**DODDRIDGE COUNTY COMMISSION
DODDRIDGE COUNTY, WEST VIRGINIA**

**DODDRIDGE COUNTY ADMINISTRATIVE ANNEX
WEST UNION, WEST VIRGINIA
THRASHER PROJECT #060-0981**

**ADDENDUM #3
NOVEMBER 13, 2020**

PHASE No.	FIRST FLOOR	SHEET No.
CONTRACT No.	Doddridge Co. Courthouse Annex	
PROJECT No.	West Union, WV	
Project Number	10-16-2020	
	FOR BIDDING	S103

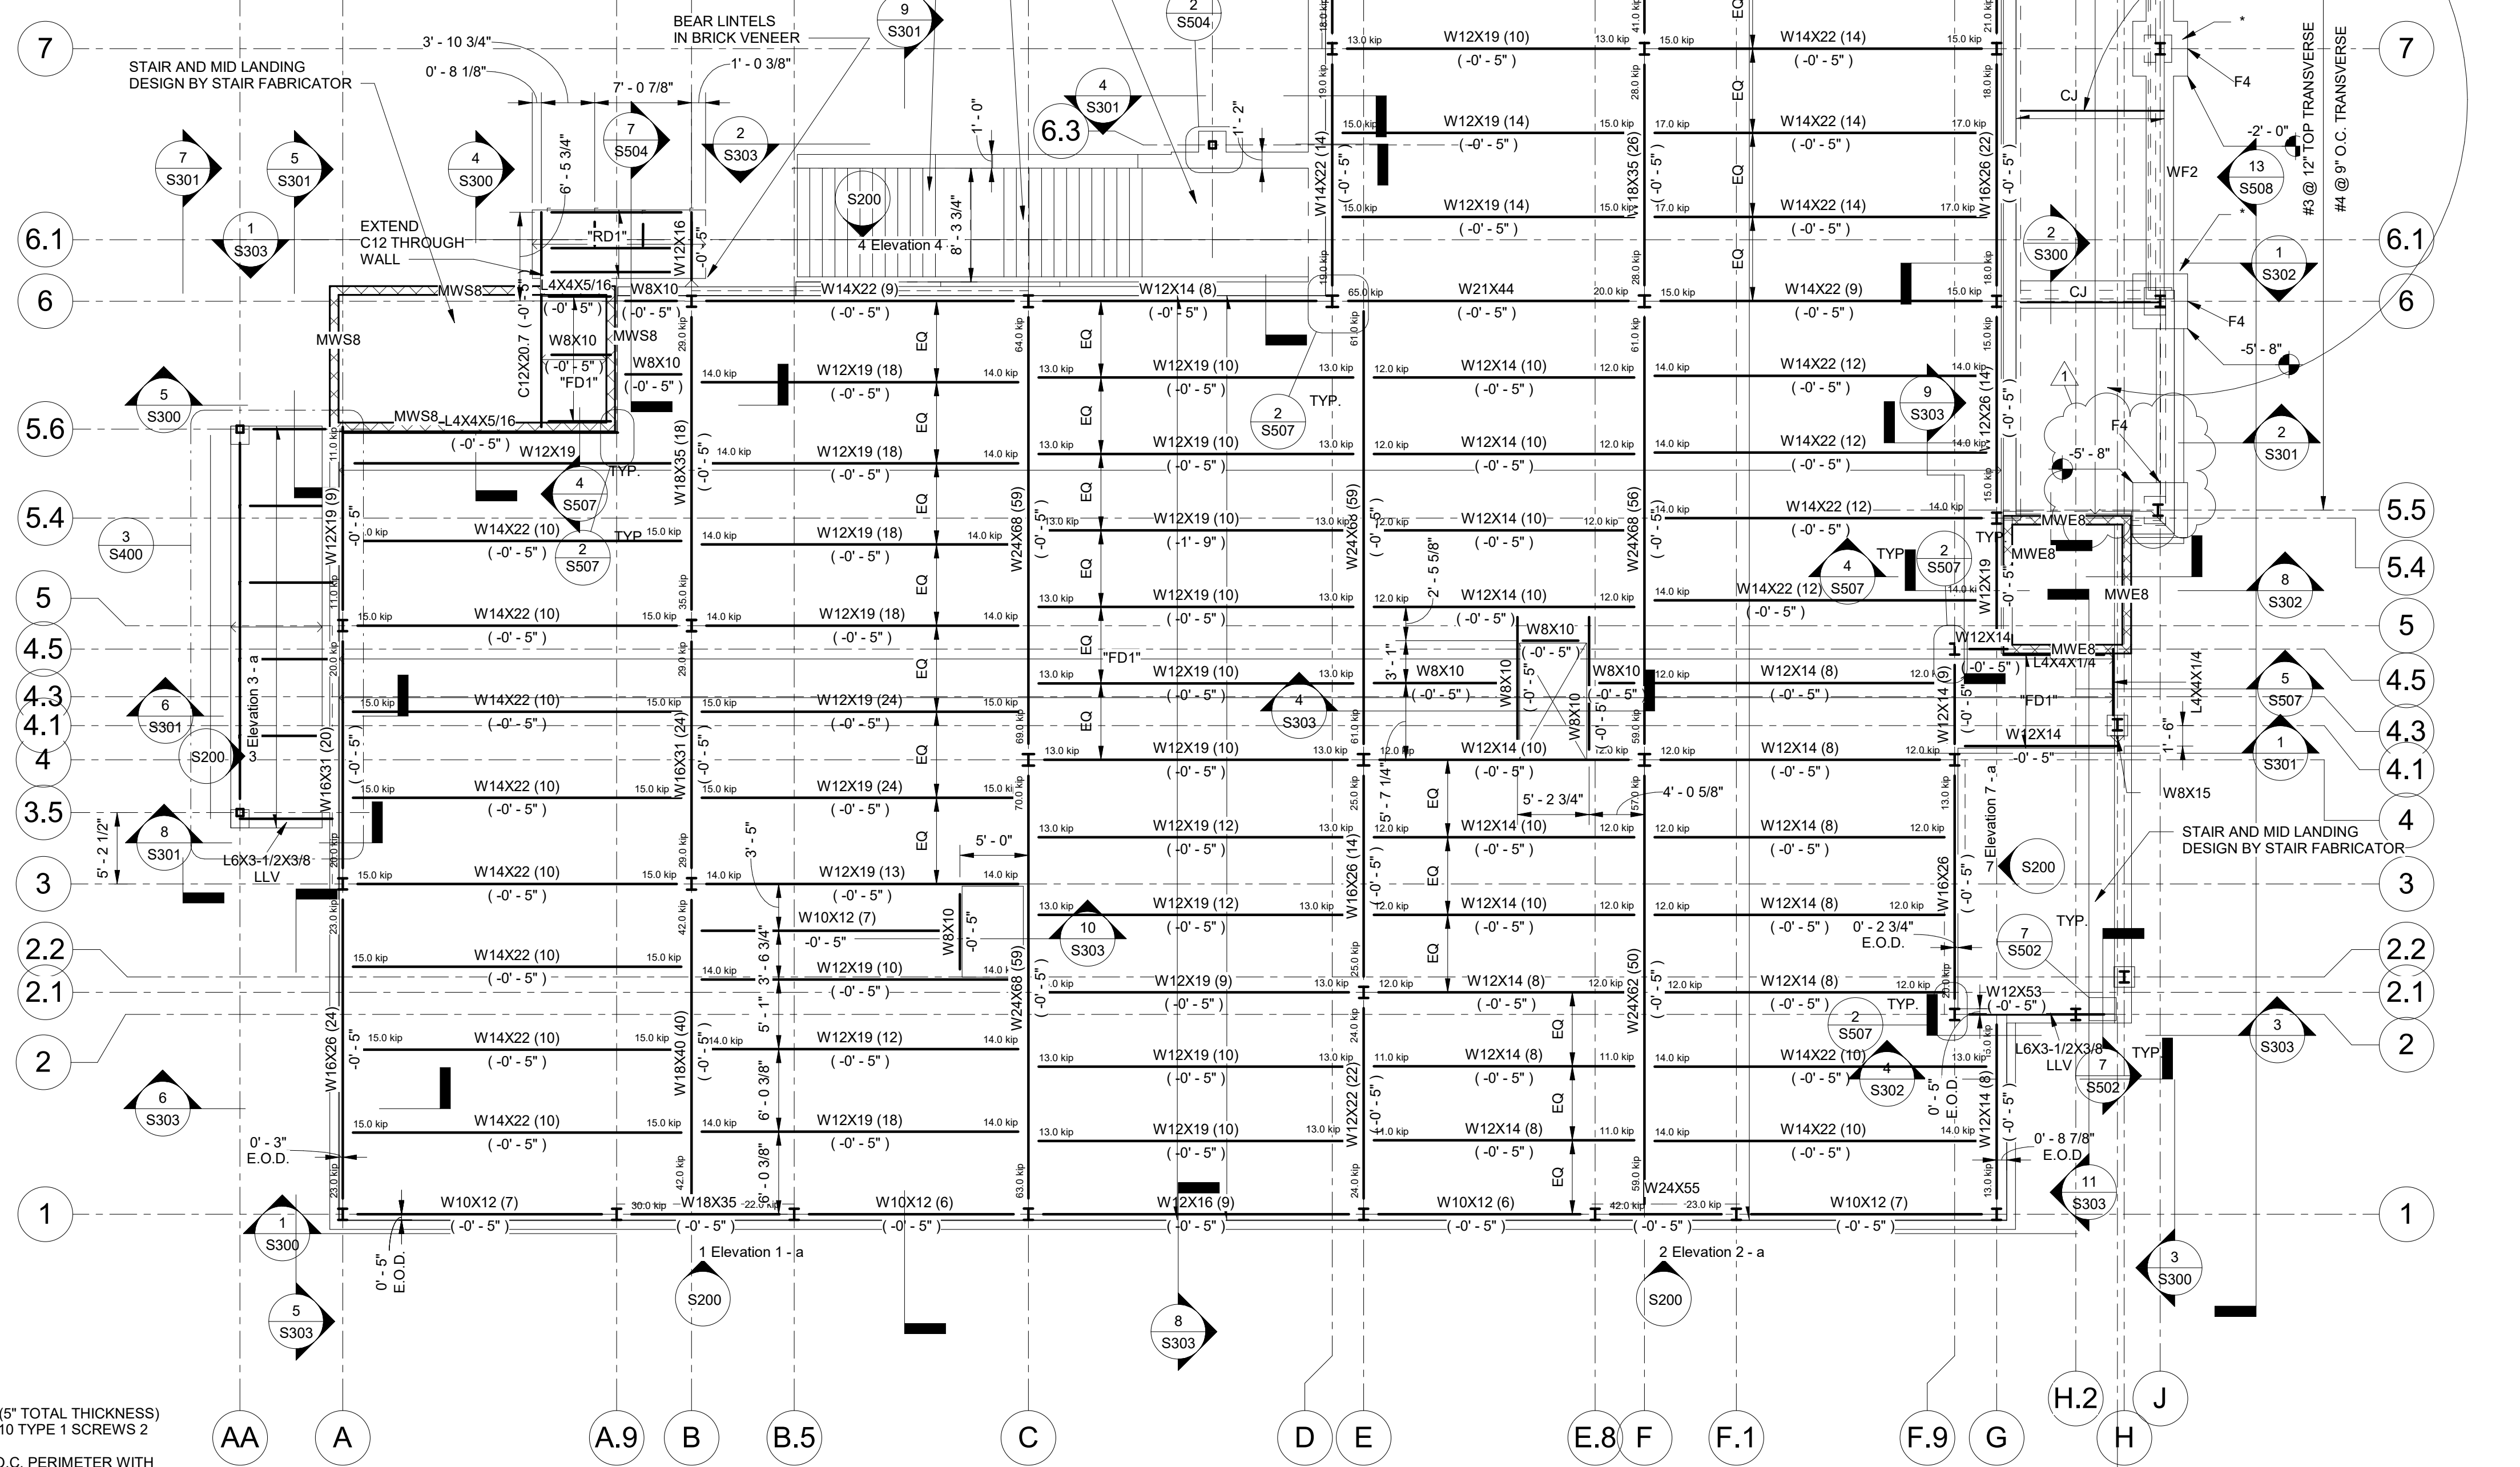
1. Drawings S103, S104, S500 and S600 are included with this Addendum.
2. C4.01 – Additional cut and fill depths for reference only.
3. C5.00 – Show all existing water lines & proposed relocated water service line.
4. 1.Reference drawing sheet M3.01 Pump Schedule P-1 and P-2, RPM shall be 1750.
5. Reference drawing sheet M3.04 Boiler Control Panel, omit points for (CO-1), (CO-2), (CO-3) and (CO-4).
6. Reference drawing sheet E3.03 Notes, Note 5; shall read “RTU #1 and RTU #2 shown on roof power plan will require duct smoke detectors in supply and return ducts.”
